Official Notice No. 153-2011  
Howard Pumping Station  
HS-26: MEDIUM VOLTAGE SOLID STATE  
MOTOR CONTROLLER INSTALLATION  
FOR PUMPS 5, 6, 7, AND 8  
September 21, 2011

**ADDENDUM NO. 1**

HS-26 RFI RESPONSES  
(O.N. 153-2011)

**OPERATING FLOOR WIRING**

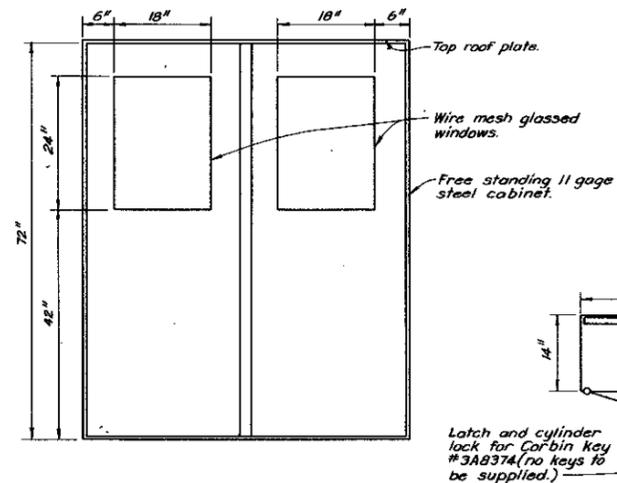
19. Is there a Valve controller for Pumps #5 & #8 similar as shown for Pumps #6 & #7? **YES. THE VALVE CONTROLLERS FOR PUMPS 5 & 8 ARE MOUNTED ON THE NORTH WALL OPPOSITE THE DISCHARGE PIPING FOR EACH PUMP. THE VALVE CONTROLLERS FOR PUMPS 5 & 8 ARE NOT SHOWN ON HS-26-05, BUT ARE SHOWN ON REFERENCE DRAWING HS-38, OPERATING FLOOR WIRING.**

23. Is there a mezzanine drawing for the location of the switchgear and the SCADA panel? **YES, SEE ATTACHMENT DRAWING HS-38, HOWARD PUMPING STATION OPERATING FLOOR WIRING.**
